## Council Agenda Correspondence

**SUBJECT:** ITEM #6b - REQUEST TO ADVERTISE THE HIGUERA COMPLETE STREETS AND REVISED 50 HIGUERA WIDENING PROJECTS FOR CONSTRUCTION

Staff received the following questions, regarding the Higuera Complete Streets Project. The questions are below in **bold** with staff's response shown in *italics*:

Excerpt from Higuera Complete Street Plans Showing Green Markings Added to Right Turn Conflict Area

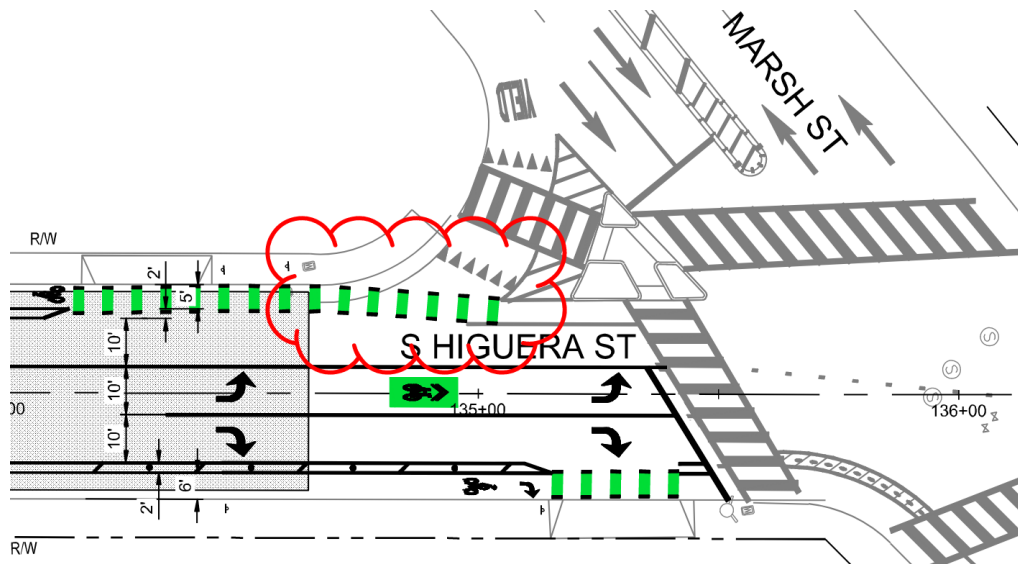
- 3) **Can further design measures be considered at the intersection of Higuera and Marsh Street to address the following concerns?**
- A. **Bicyclists traveling southbound on Higuera approaching Marsh Street have to merge across vehicles entering the right-turn lane heading towards the US 101 ramps, which can be uncomfortable.**
  - B. **Eastbound drivers exiting the US 101 ramps and turning right to southbound Higuera frequently do not stop or yield to southbound bicyclists.**

*Concern B: Eastbound drivers exiting the US 101 ramps and turning right onto southbound Higuera have been observed failing to adequately yield to bicyclists.*

*The Higuera Complete Streets Project includes high-visibility green pavement markings through the conflict area to increase awareness of the bicycle crossing and improve yielding behavior (see plan excerpt below for reference).*

Additional measures that could be explored in a future project include removing the existing channelized right-turn configuration and/or converting the right-turn movement from yield control to signal control. Under a signalized configuration, drivers would be legally required to stop on red before proceeding. A similar conversion was recently completed at the westbound approach to the Higuera/Tank Farm intersection, which required traffic signal reconstruction.

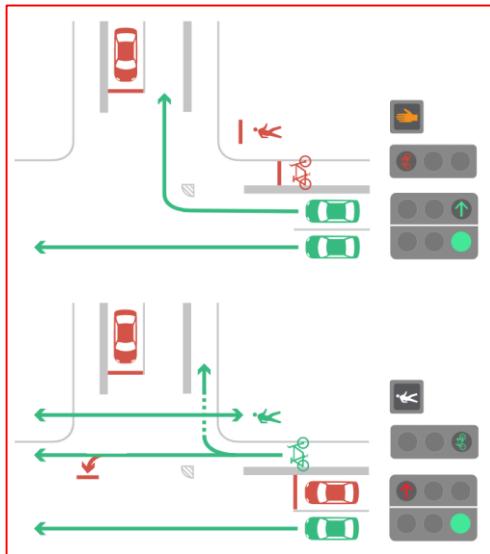
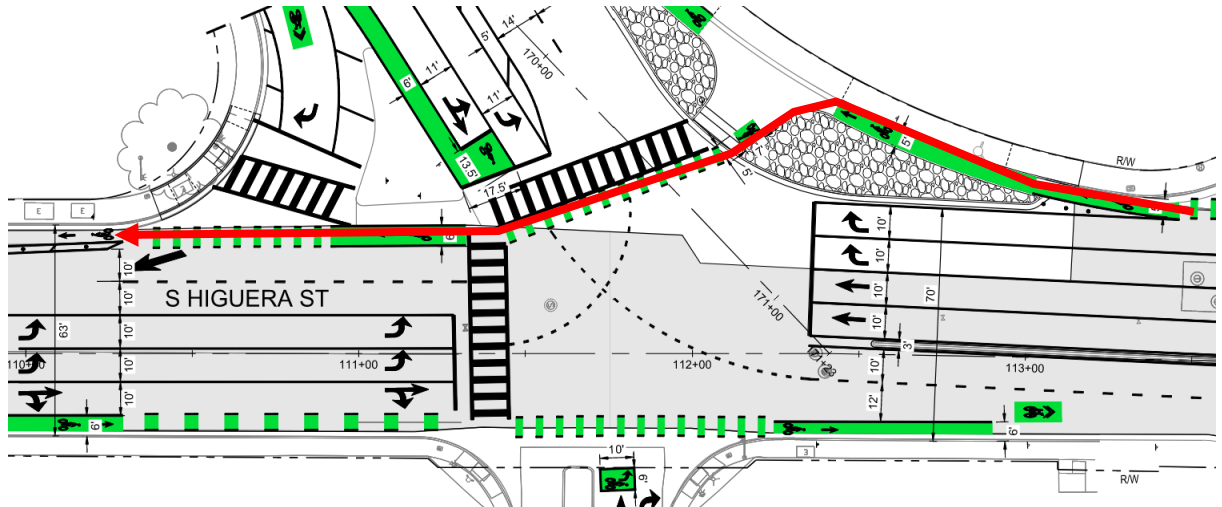
- 4) Please confirm the intended path for southbound cyclists to navigate the Higuera & Madonna intersection with the proposed project and how conflicts between cyclists and right-turning vehicles are addressed.

The plans include reconfiguration of the northwest corner of the Higuera/Madonna intersection and modifications to the traffic signal to eliminate the need for southbound cyclists to weave across multiple traffic lanes to continue southbound.

With the proposed improvements in place, southbound cyclists will remain on the right side of the roadway as they approach and enter the intersection. Cyclists will proceed through the intersection using a new dedicated bicycle signal phase. During this phase, right-turning vehicular traffic will receive a red light and will be subject to NO RIGHT ON RED restrictions.

See plan excerpt and example traffic signal phasing graphic below for reference.

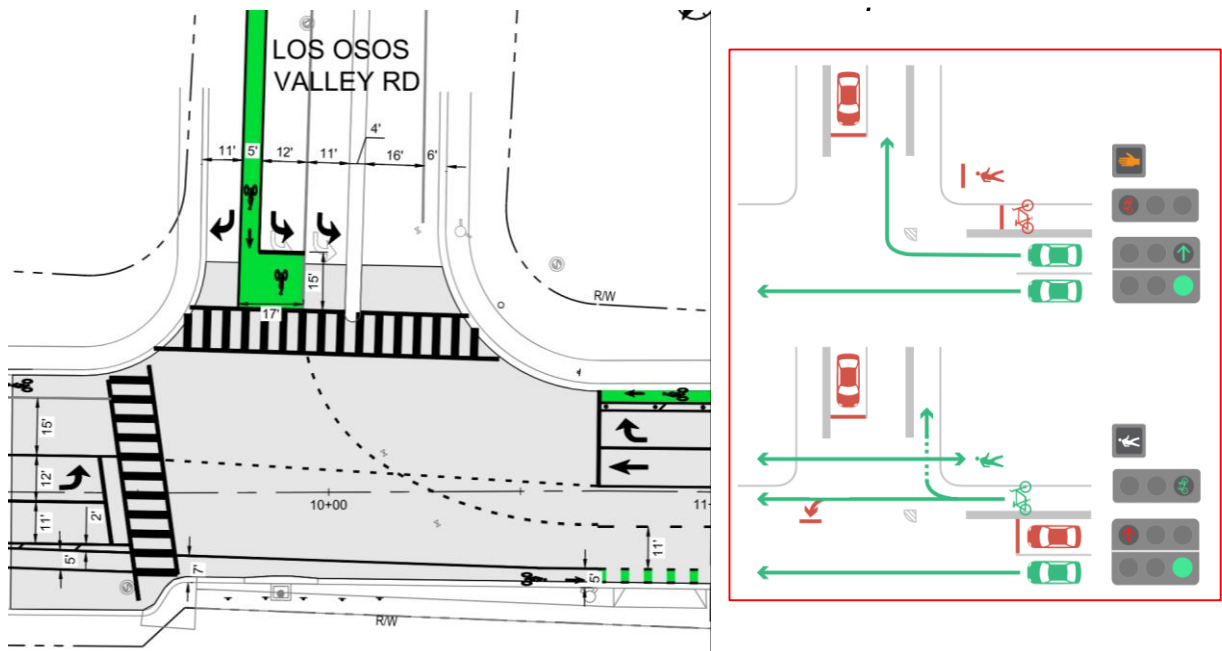
**6) Please confirm the intended path for southbound cyclists to navigate the Higuera & Los Osos Valley Road intersection with the proposed project and how conflicts between cyclists and right-turning vehicles are addressed. Are there design measures that can be explored to improve options for cyclists traveling northbound on Higuera to make a left turn to westbound Los Osos Valley Road?**

*For southbound cyclists, the design approach at the Higuera/Los Osos Valley Road intersection is consistent with the treatment proposed at Higuera/Madonna.*

*Under the proposed project, the southbound bicycle lane is realigned to remain along the curbside rather than requiring cyclists to weave across right-turning vehicle traffic. A new dedicated bicycle signal phase will allow southbound cyclists to proceed through the intersection while right-turning vehicles receive a red indication. This signal separation reduces vehicle–bicycle conflicts and eliminates the previous merge condition.*

Regarding northbound cyclists seeking to turn left onto westbound Los Osos Valley Road, the current design maintains standard vehicular left-turn operations. Cyclists traveling northbound may merge into the left-turn lane and complete the turn as a vehicle would, or they may use a two-stage turn maneuver (crossing first and then repositioning to complete the turn during a subsequent signal phase).

If Council is interested in further enhancing this movement, staff could evaluate the addition of a bicycle two-stage left-turn box (also known as a bike turn box) on the northbound approach. This treatment—similar to what is proposed on the eastbound Los Osos Valley Road approach—would provide a designated waiting area within the intersection to facilitate a more comfortable two-stage left-turn maneuver for cyclists.

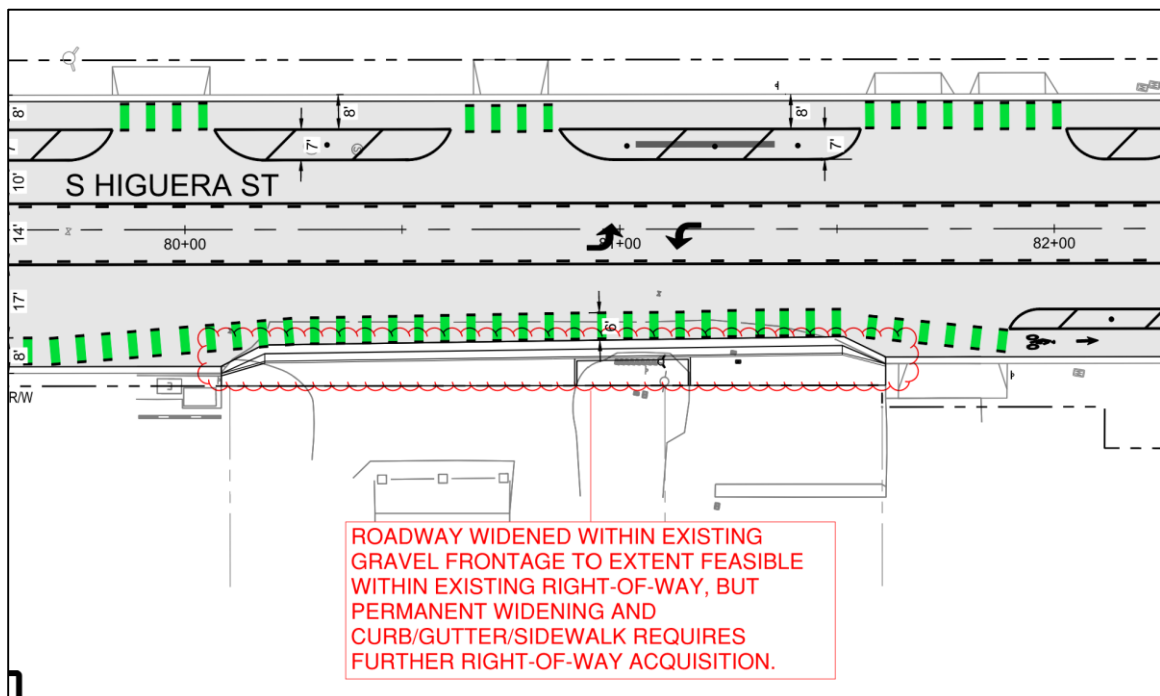
- 8) Does the proposed work on Higuera street address removing the dirt/gravel parking lot driveway intruding into the bike path, located just north of the Chumash Village access? Did the City acquire the rights to remove this property? What is the plan for future right-of-way acquisition, and are there any options for protecting northbound bicyclists where they encounter the lane narrowing due to the narrower street width?**

*The current Complete Streets Project therefore includes partial roadway widening and temporary gutter/drainage improvements that can be constructed within the existing public right-of-way. These improvements do not preclude future full roadway widening if right-of-way acquisition is ultimately successful.*

Regarding protection for northbound bicyclists through the approximately 200-foot constrained segment north of Chumash Drive: this stretch includes a bus stop and multiple driveways without formalized curb cuts. Due to these access points and the limited roadway width, installation of continuous vertical separation (such as curb-protected bike lanes or delineator posts) is not feasible at this time.

To improve visibility and awareness within these constraints, the project includes continuous dashed green pavement markings through the narrowed segment to highlight the shared space and increase driver awareness of bicyclists. While no physical separation is provided under the current design, additional protective measures could be revisited in the future if right-of-way acquisition is achieved and the corridor can be fully reconstructed.

See the attached plan excerpt for additional detail on the design treatment at this pinch point.

Excerpt from Mid Higuera Enhancement Plan

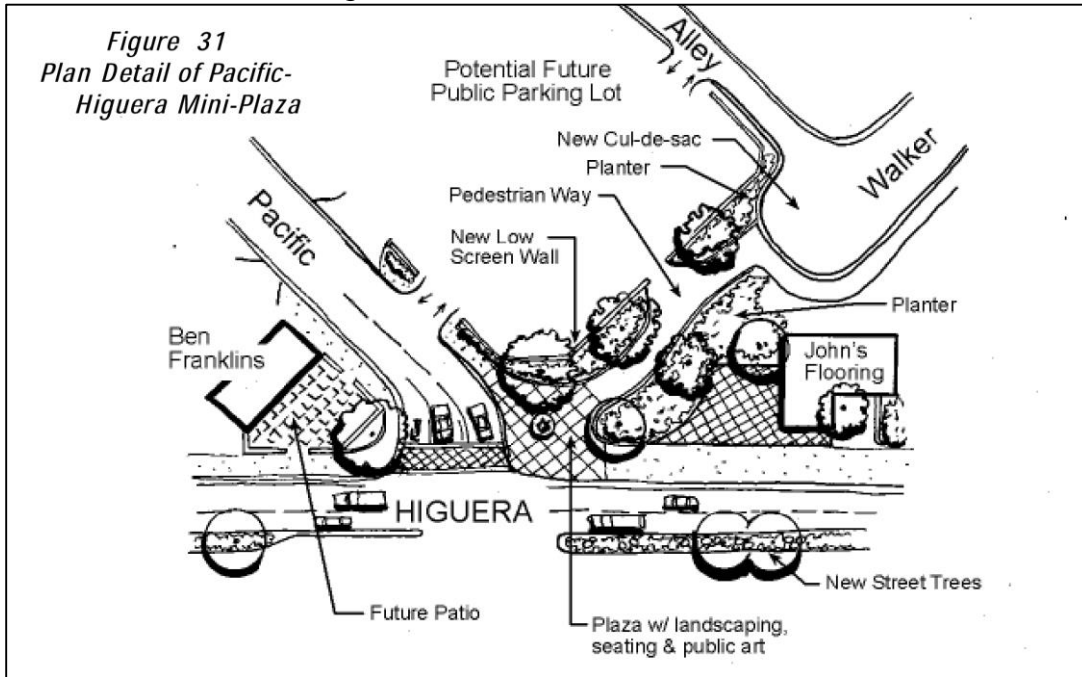
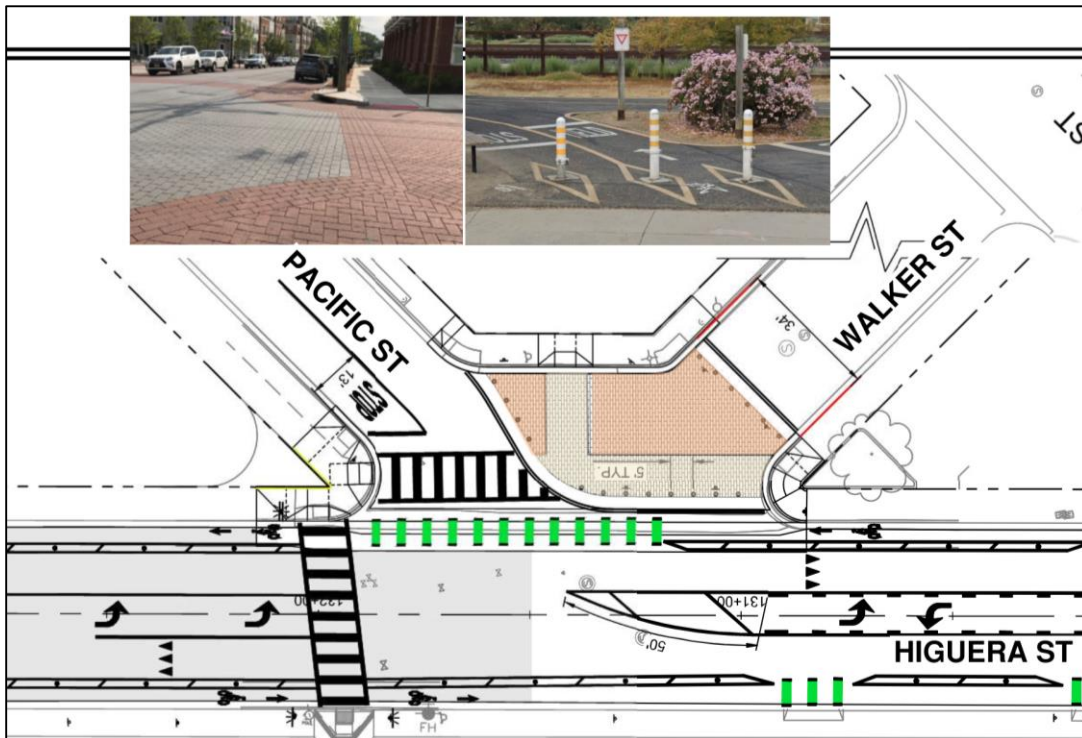
**11) Is the plan for the Walker Street closure completely in line with what is presented in the Mid-Higuera Enhancement Plan? I wasn't sure if the plans as presented here are a modification or a simplification of that vision. Is it only Walker between Pacific and Pismo that will be impacted?**

*The proposed Walker Street closure is functionally consistent with the vision outlined in the Mid-Higuera Enhancement Plan; however, the current project represents a more modest, interim implementation rather than the full long-term buildout envisioned in that plan.*

*The current project advances the functional and safety objective identified in the Mid-Higuera Enhancement Plan, closing one leg of the irregular intersection consistent with the Mid Higuera Enhancement Plan with more interim to improve safety and simplify operations, while implementing more interim improvements that can be constructed within the existing public right-of-way and available budget.*

Importantly, the proposed design does not preclude future construction of the more permanent pedestrian plaza envisioned in the Mid-Higuera Enhancement Plan, should funding and right-of-way acquisition opportunities arise.

The closure only impacts Walker Street between Pacific Street and Pismo Street, consistent with the configuration shown in the Enhancement Plan.

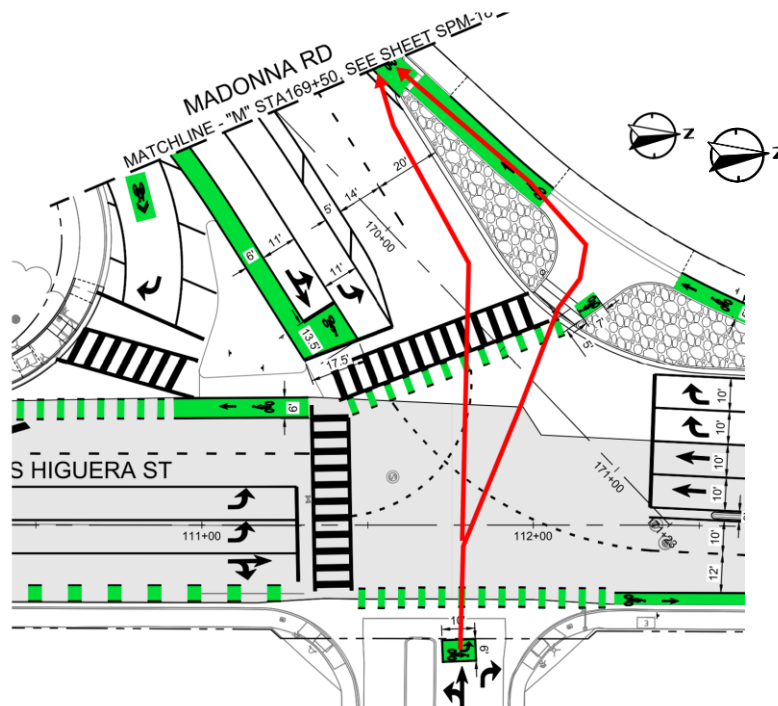
19) Page 359 of the packet shows the intersections at Bridge Street and South Higuera as well as Madonna/S. Higuera. Great changes are proposed for Bridge/S. Higuera. And there are also changes proposed for southbound bike/car traffic on South Higuera and for those turning right onto Madonna. However, can you please clarify:

- a) What intended path of travel would be for riders leaving the shopping center driveway, continuing onto Madonna?

*As shown in the image below, cyclists exiting the Pacific Coast Center and desiring to continue westbound to Madonna Road would have two options:*

1. *Use the bike/pedestrian ramp at the northwest corner to access the westbound bike lane; or*
2. *Continue in the vehicle lane briefly and merge into the street-level westbound bike lane downstream.*

*Under the current and proposed signal phasing, no other vehicles are permitted to turn onto westbound Madonna Road concurrently with westbound cyclists. Therefore, under Option 2, cyclists would not encounter conflicting turning vehicle traffic, other than vehicles also exiting the shopping center driveway.*
